**CALIFORNIA COASTAL COMMISSION**

**STAFF REPORT: APPEAL****SUBSTANTIAL ISSUE**

| <b>APPEAL NO.:</b>          | <b>A-1-MEN-05-029</b>  |
| <b>APPLICANTS:</b>          | <b>Charles and Dale Phelps</b>   |

GARAGE FLOOR PLAN

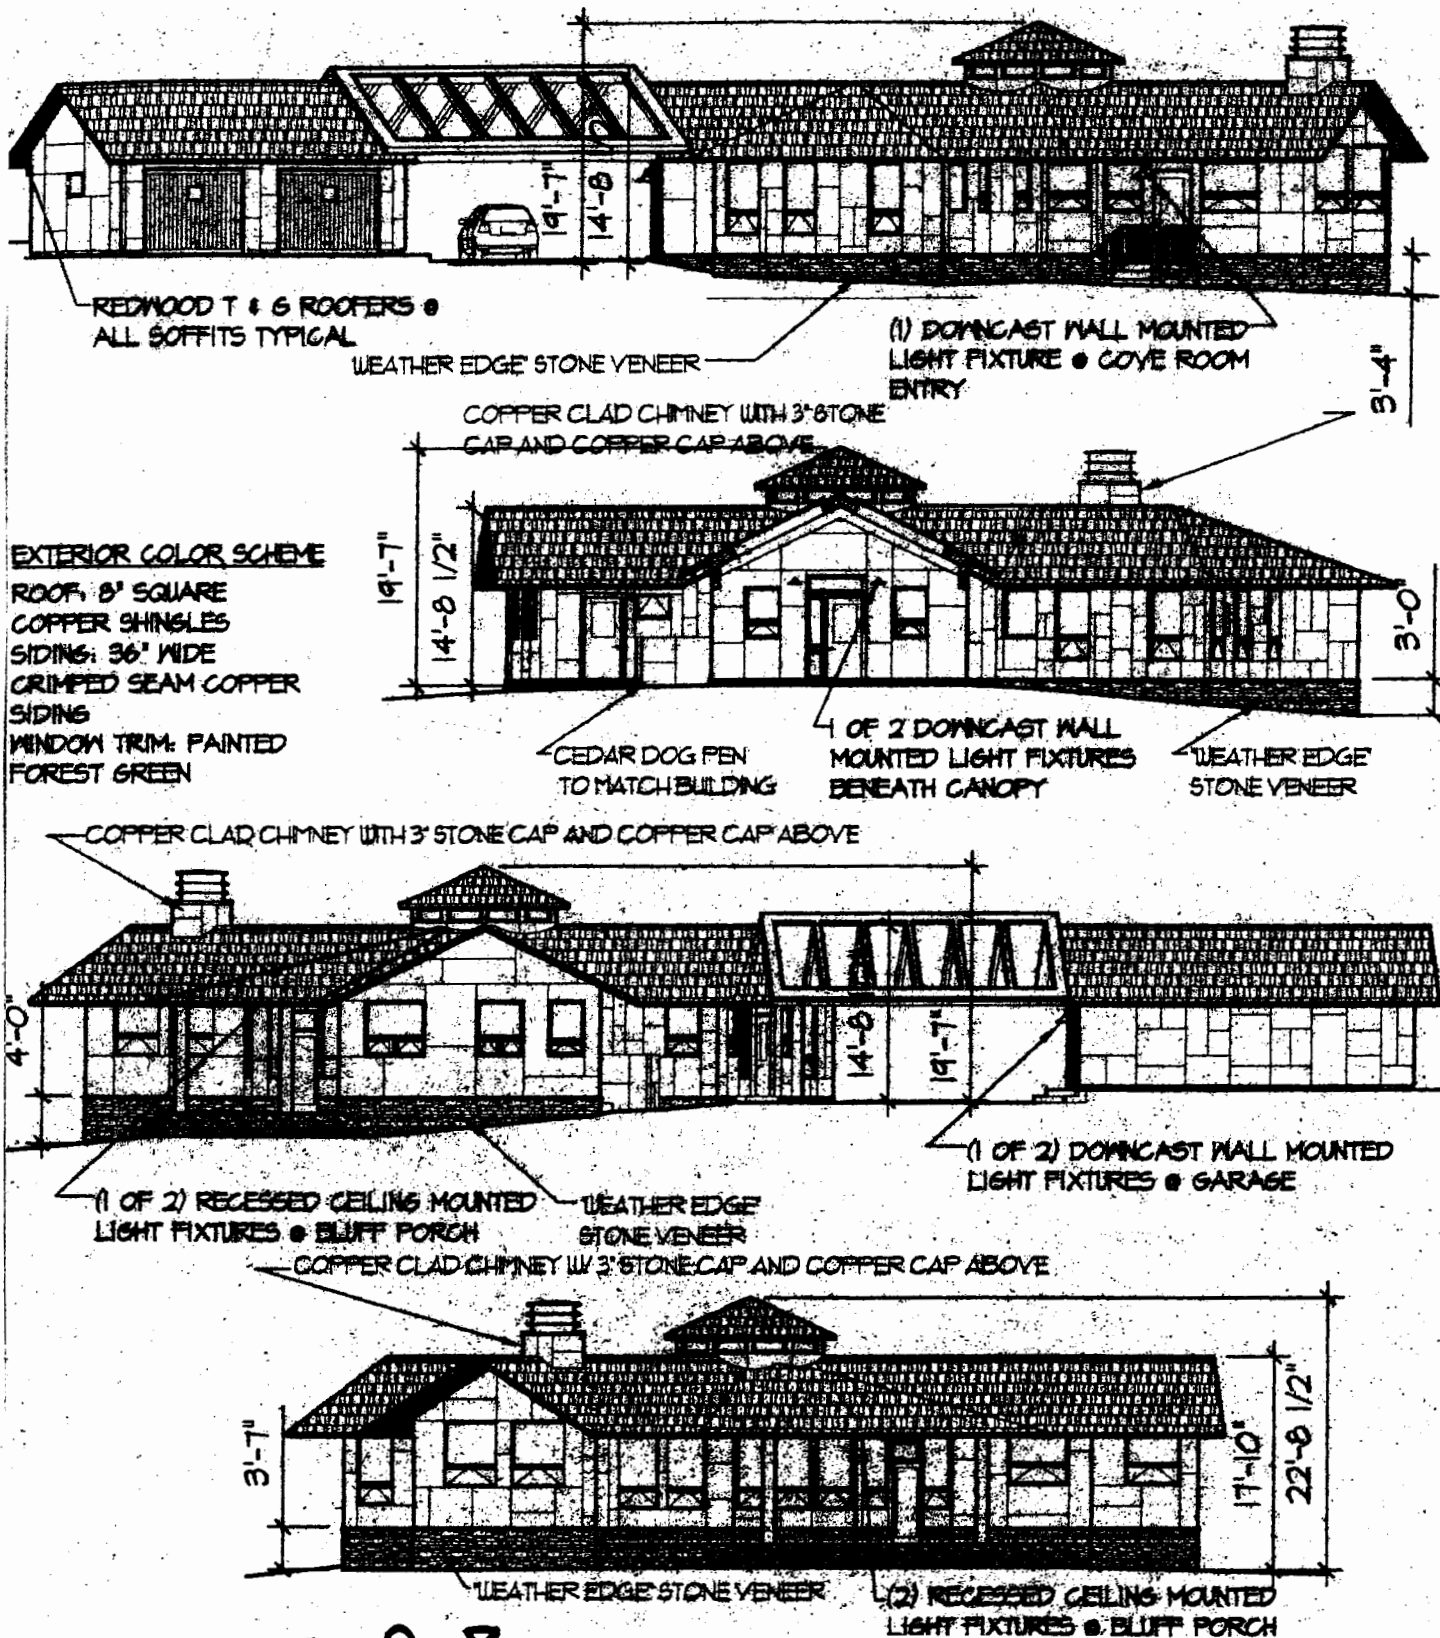
The floor plan for the guest cottage shows a counter and sink within the living area. Section 20.308.050(G)(I) of the Code prohibits a kitchen within a guest cottage. In response to correspondence between staff and the applicant's agent, Ed McKinley, a letter dated October 7, 2004 was submitted stating that the counter and sink in the living area of the guest cottage are deleted from the application. To emphasize County Code requirements that a guest cottage may not contain a kitchen and cannot be used as an independent dwelling unit or be rented separately from the primary residence, Special Condition Number 1 is recommended.
